ISSUE: Permit to Demolish/Capsulate (partial) and Certificate of Appropriateness

LOCATION: Old and Historic Alexandria District

414 North Union Street

Docket #6 & 7 BAR #2021-00004 & 2021-00005 (C) Old and Historic Alexandria District January 19, 2022

Figure 5: Proposed east elevation

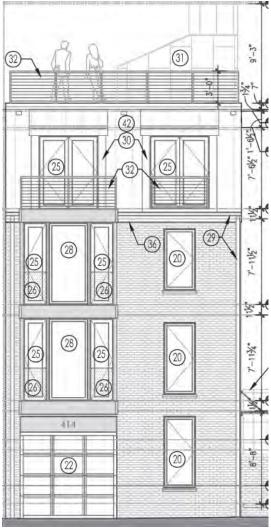
East elevation:

The applicant proposes replacing all windows and doors on this elevation. The new design is balanced, symmetrical, and in scale with the streetscape. See Figure 5. The mansard roof will be

altered to allow for additional living space on the third floor. The changed roofline will be composed of pre-finished metal roofing, pre-finished metal dormers with cable railings, and terrace doors with sidelights and metal cable railing. The bay windows on the two levels below the new dormers include terrace doors with sidelights and tempered glass railings. New metal and glass garage doors will complement the new windows. The BAR approved similar bay windows and garage doors at 100 Quay (BAR2014-00032 & 00033, approved March 5, 2014), Figure 6.

Figure 7: Option A, north elevation

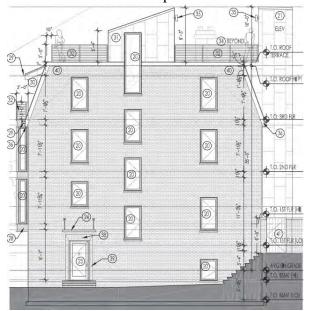
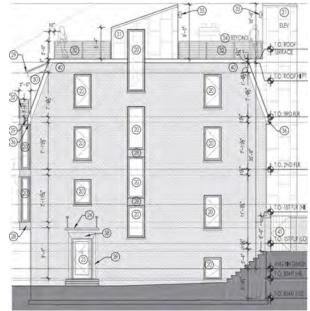
The applicant proposes replacing the existing pediment over the entry door with a brick jack arch matching the door surround. A new metal and glass canopy with LED downlighting will be added above the door. This type of canopy has been approved by the BAR in this community in the past, most recently for 105 Queen Street (BAR2021-00457, approved 12/15/21). In that case, the BAR specifically recommended that the applicant replace the door entablature with a metal and glass canopy. The applicant also proposes adding six windows to this elevation, providing two options for the BAR's consideration. Both options provide a degree of symmetry that is missing from the current design. In Option A (Figure 7), the central vertical line of windows has distinct separations,

with masonry bands separating them. Option B (Figure 8) links the windows, creating a single long bay. In staff opinion, Option A appears more symmetrical and balanced than Option B, and therefore recommends Option A.

Staff therefore recommends approval of the project with the recommendation that the applicant select Option A for the north elevation.
